**SOLICITATION AMENDMENT**

<b>Title - Sujet</b> Admin. Building Roof Renewal	
<b>Solicitation No. - N° de l'invitation</b> F1700-150843/A	<b>Amendment No. - N° modif.</b> 003
<b>Client Reference No. - N° de référence du client</b> F1700-150843	<b>Date</b> 2016-03-07
<b>GETS Reference No. - N° de référence de SEAG</b> PW-\$PWY-031-7754	
<b>File No. - N° de dossier</b> PWY-5-38394 (031)	<b>CCC No./N° CCC - FMS No./N° VME</b>
<b>Solicitation Closes - L'invitation prend fin</b> <b>at - à 02:00 PM</b> <b>on - le 2016-03-16</b>	
<b>F.O.B. - F.A.B.</b> <b>Plant-Usine:</b> <input type="checkbox"/> <b>Destination:</b> <input checked="" type="checkbox"/> <b>Other-Autre:</b> <input type="checkbox"/>	
<b>Address Enquiries to: - Adresser toutes questions à:</b> Leung, Janie	<b>Buyer Id - Id de l'acheteur</b> pwy031
<b>Telephone No. - N° de téléphone</b> (604) 666-8228 ( )	<b>FAX No. - N° de FAX</b> (604) 775-6633
<b>Destination - of Goods, Services, and Construction:</b> <b>Destination - des biens, services et construction:</b> DFO - Administration Building - Coast Guard Base - Victoria, BC

- 1) Extend the solicitation closing date
- 2) Address questions
- 3) Incorporate Addendum 2
- 4) Updat

**WALL SECTIONS & MISCELLANEOUS DETAILS - 1.**

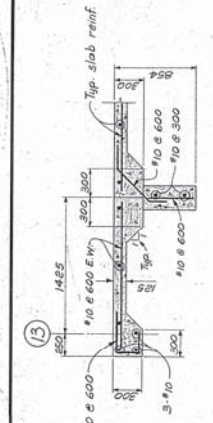
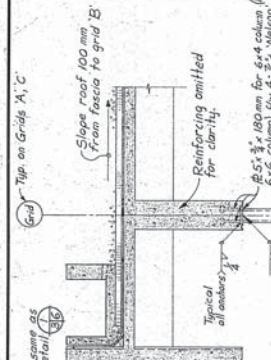
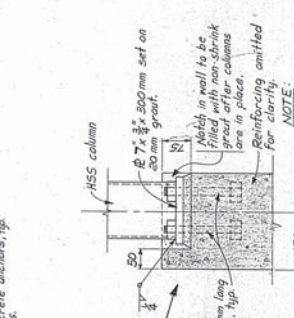
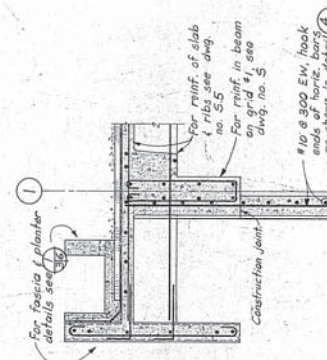
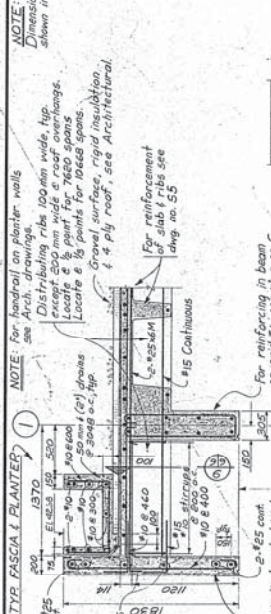
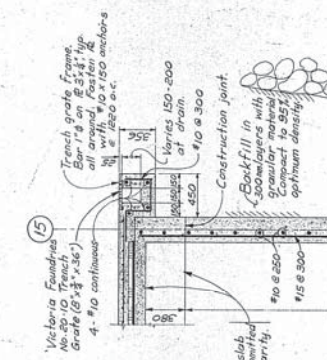
**Q3.** We need as built drawings for concrete planter wall that is being removed. Is there rebar in it tying into slab?

3. **Concrete Planter As Built Drawing** – See attached drawing
4. **Milestones** – Change Milestone dates in Project Summary.

**A3.** Please see addendum #2.
